Applicant: Carter Schulze; City of Eden Prairie  
Consultant: Miranda Etienne; Bolton and Menk, Inc.  
Project: Willow Creek Road Culvert Replacement  
Location: Between 7221 and 7240 Willow Creek Road, Eden Prairie  
Applicable Rule(s): 2, 3, 4, 5 and 7  
Reviewer(s): Louise Heffernan and Janna Kieffer; Barr Engineering Co.

The City of Eden Prairie (City) is proposing the replacement of deteriorating corrugated metal culverts beneath Willow Creek Road along the South Fork of Nine Mile Creek, a Minnesota Department of Natural Resources (MDNR) Public Watercourse. The culverts serve as the outlet to Bryant Lake, MDNR Public Water #67P.

EDEN PRAIRIE, MINNESOTA  
WILLOW CREEK ROAD  
TEMPORARY ACCESS ROAD PLAN & PROFILE

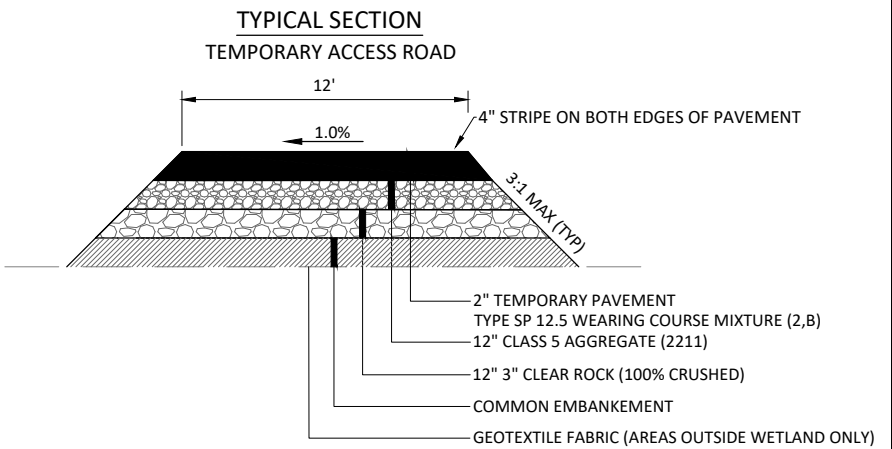
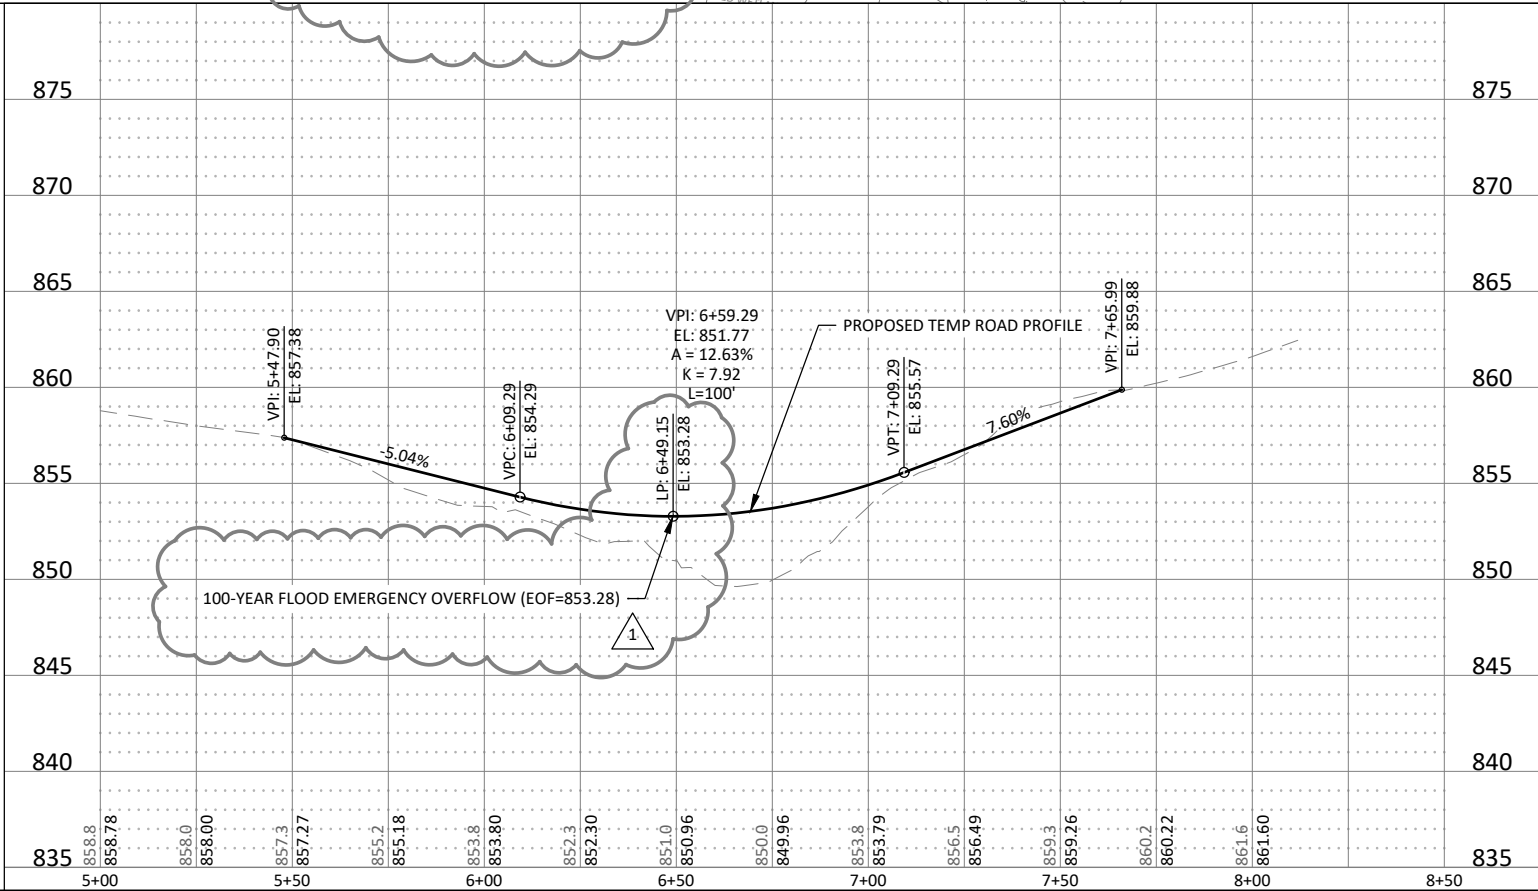
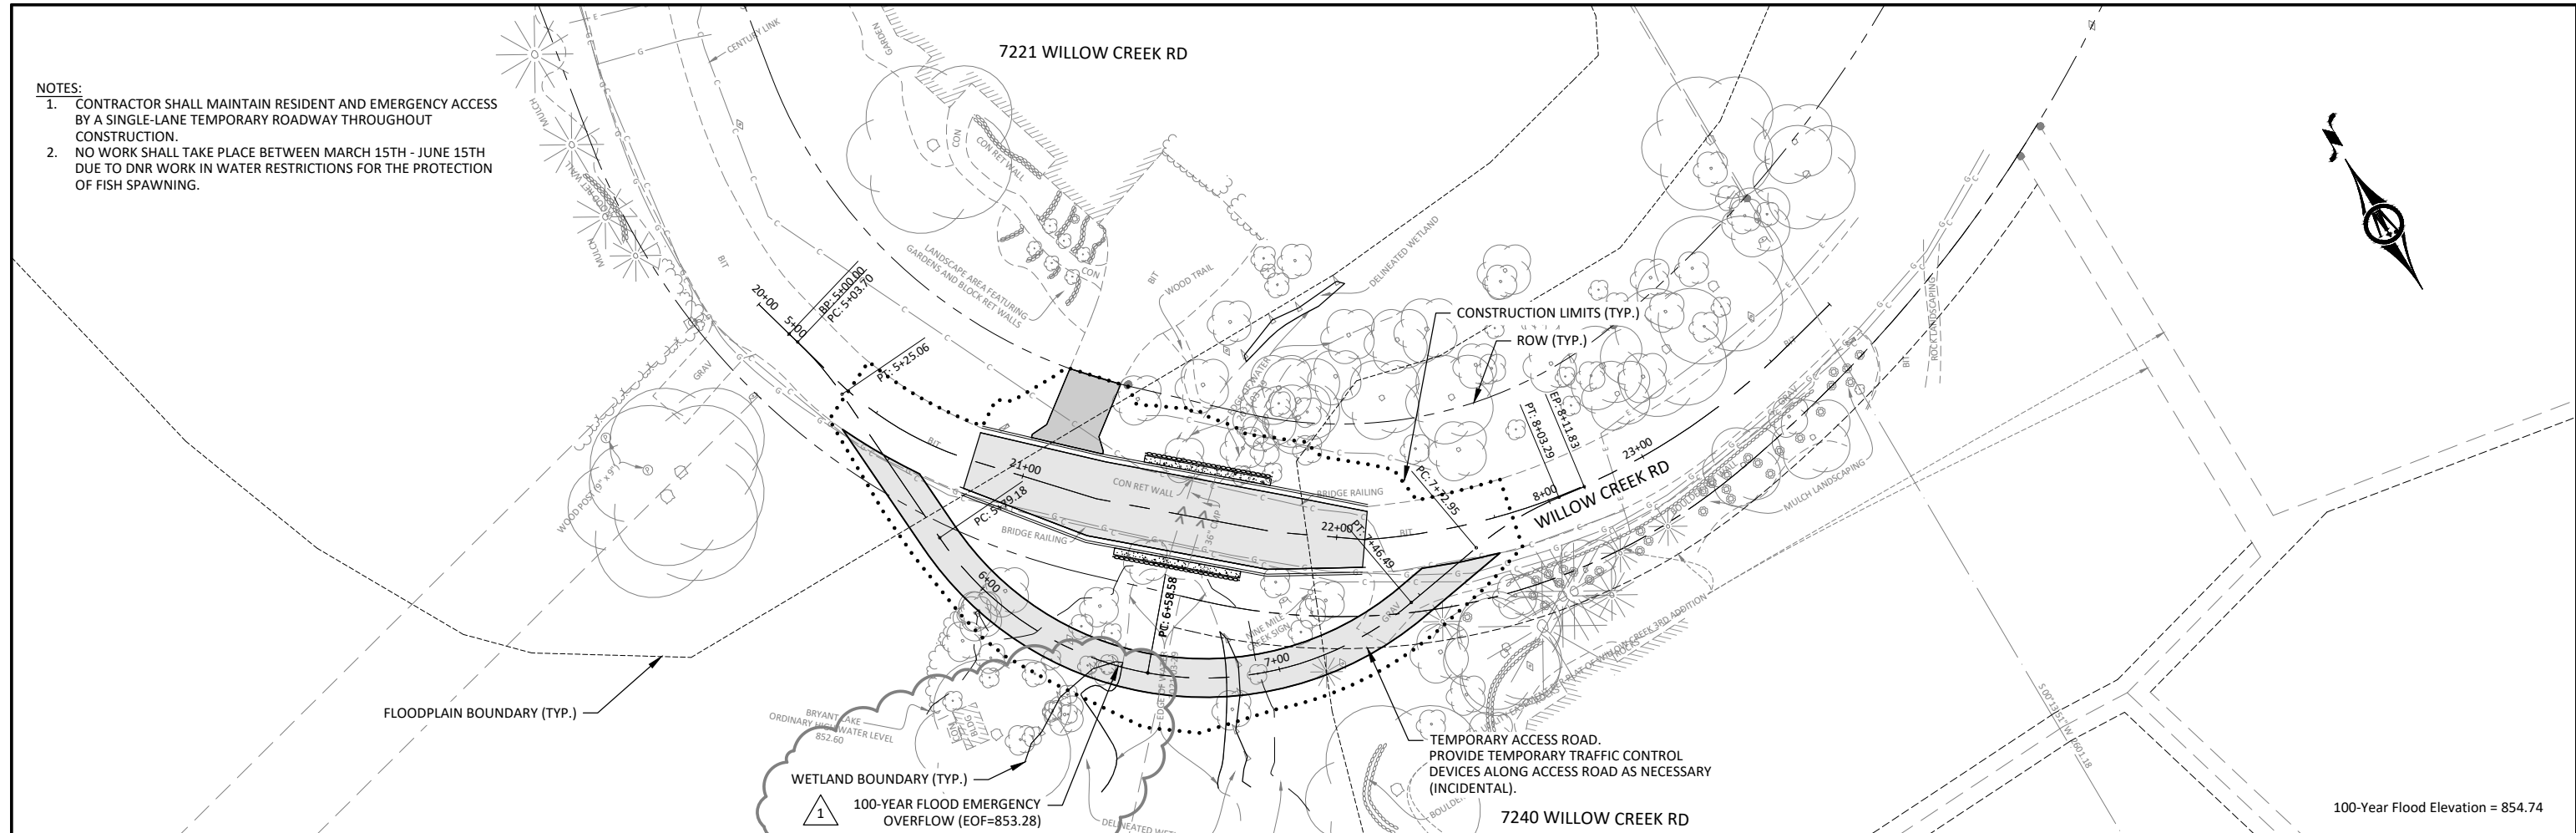
3. Prior to the issuance of a NMCWD permit, the applicant must demonstrate compliance with the NMCWD floodplain management and drainage alterations criteria for the work including the installation of the temporary access road construction. Demonstration that the construction of the temporary access road will not have a significant adverse impact on any upstream or downstream landowners and is not reasonably likely to have a significant adverse effect on flood risk, basin or channel stability, groundwater hydrology, stream base-flow, water quality or aquatic or riparian habitat must be provided. The following, at a minimum, must be provided:

- a. Identification of the construction timeline, including a sequencing and staging plan for construction activities and the control of water within the work area. The duration of bypassing creek flow due to culvert replacement should be minimized.

- b. Documentation regarding how baseflow (variable, approximately 4.0 c.f.s.) will be maintained throughout the duration of construction.
- c. Documentation that the existing 100-year frequency hydraulic capacity at the Willow Creek Road crossing will be maintained throughout the duration of construction and that the 100-year flood risk in Bryant Lake or in the downstream creek system will not be increased.

- d. The proposed construction has the potential to cumulatively result in volume increases and associated increases in water level upstream of the temporary bypass, pumping or conveyance system, following smaller, more frequent storm events. Documentation must be submitted showing that the water management plan is not reasonably likely to have significant adverse impacts on the upstream flood risk for the 100-year storm event. The documentation must include triggers for supplemental action(s) in response to increasing lake elevations and must show long duration stage increases will be prevented.

- e. If water levels and flow volumes are controlled in the work area by pumping, the pump capacity and equipment model must be provided.
- f. If the temporary access road, as shown on the preliminary plans, is designed to be overtopped to pass creek flows during extreme events, the controlling overflow elevation of the temporary access road must be identified.
